ADDENDUM 1 (PENDING DSA APPROVAL)

PROJECT: **Santa Ana College**
 Science Center

DATE: 8/23/2017

DSA File No.: 30-C2
DSA Applications No.: 04-115788
HGA Commission No.: 3584-001-00

2 EXTERIOR DETAIL AT SLAB EDGE
 1 1/2" = 1'-0"

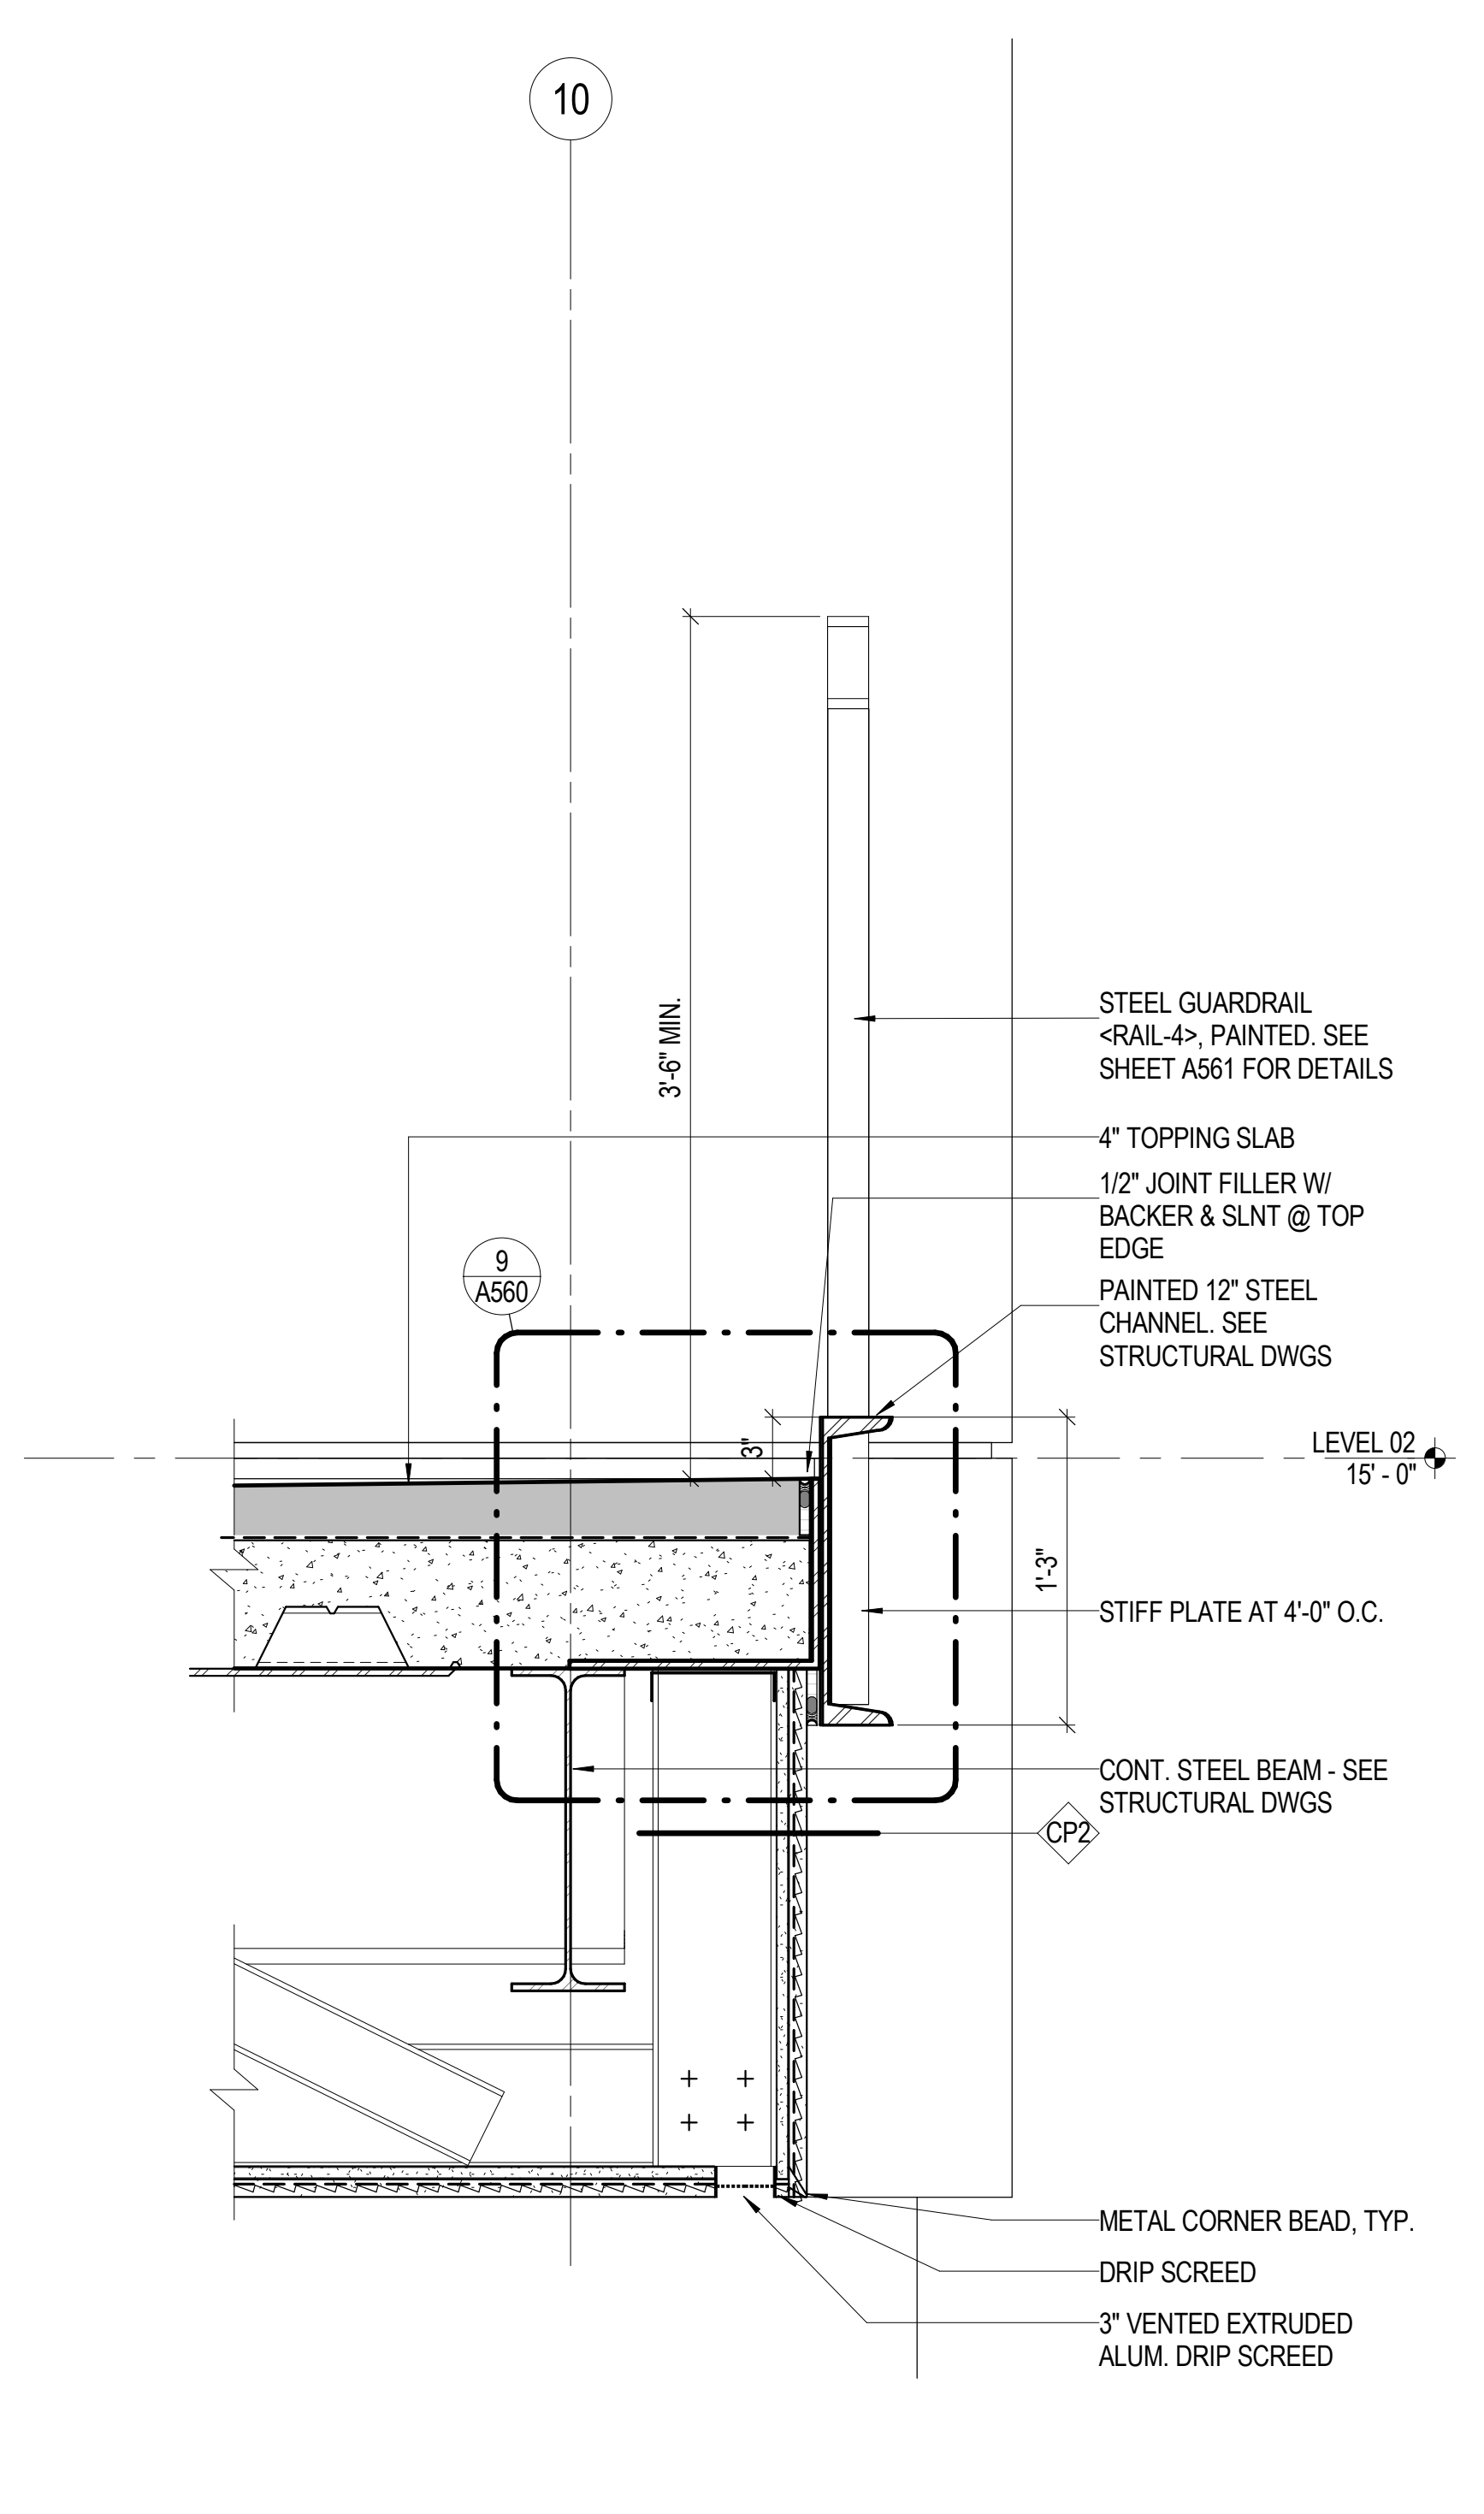
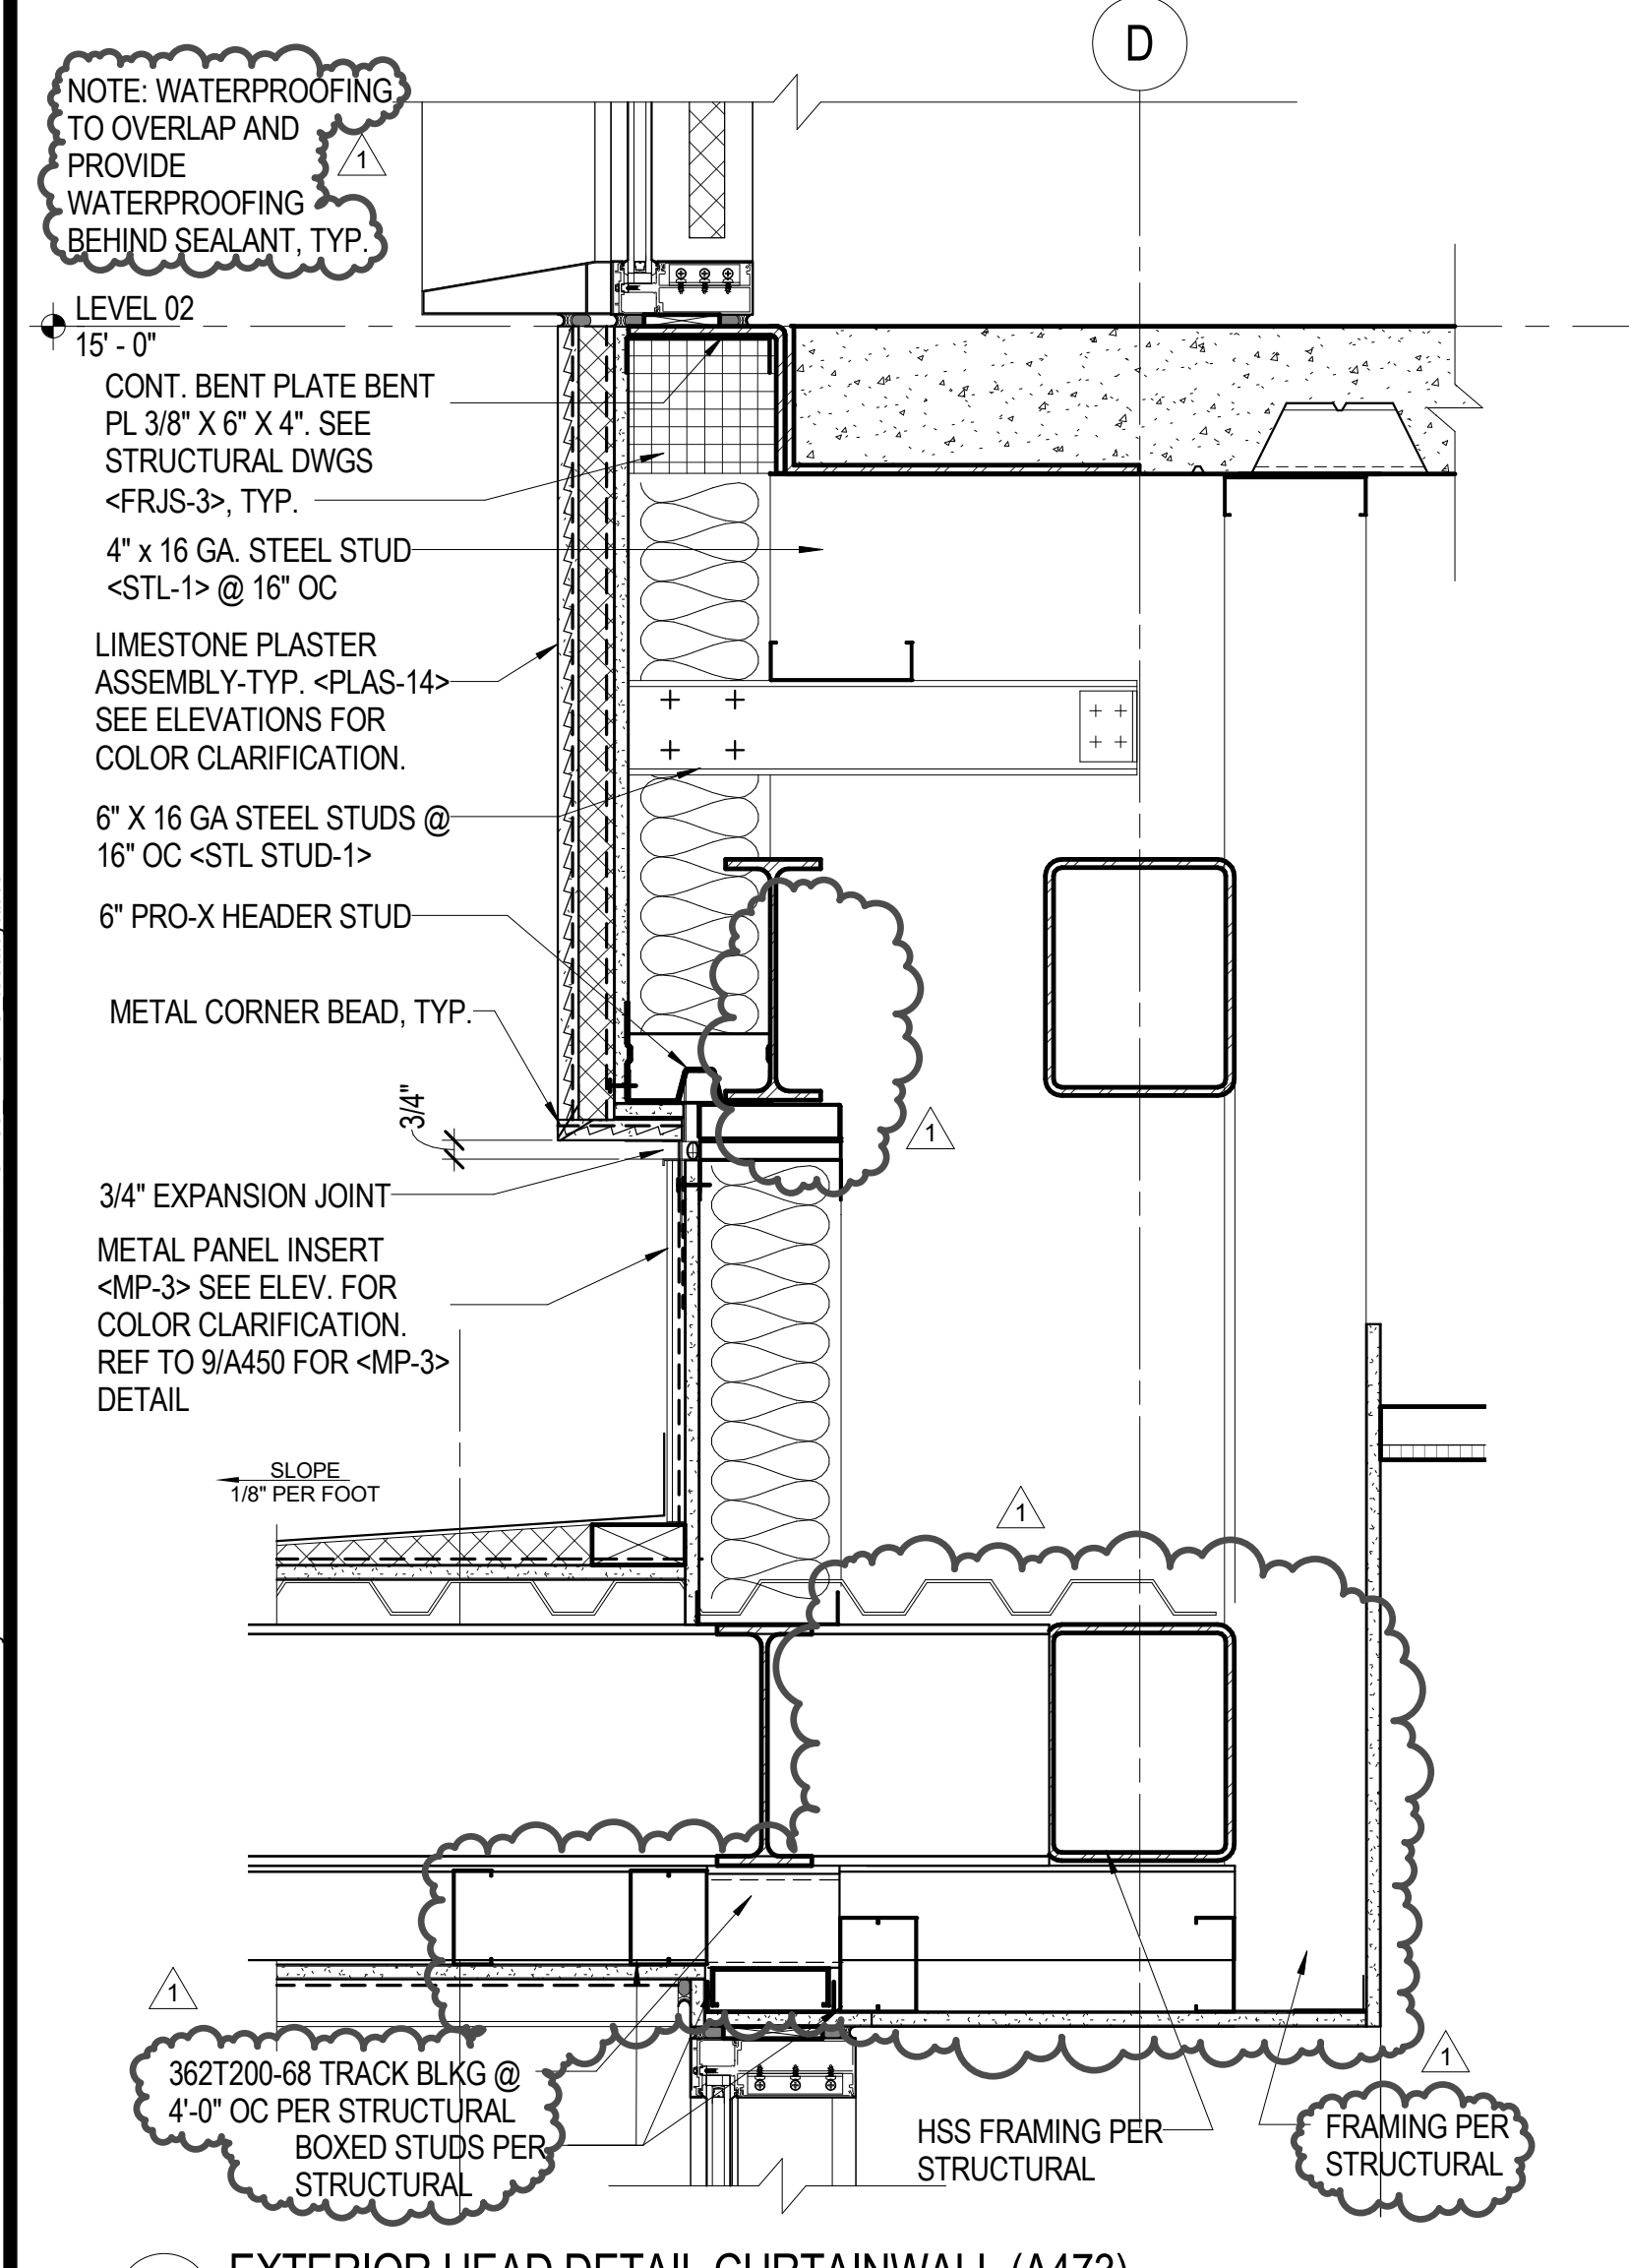
- Gutter removed from roof at north canopy at Details 1.
- Framing at canopy revised to match structural drawings at Details 1 and 4.
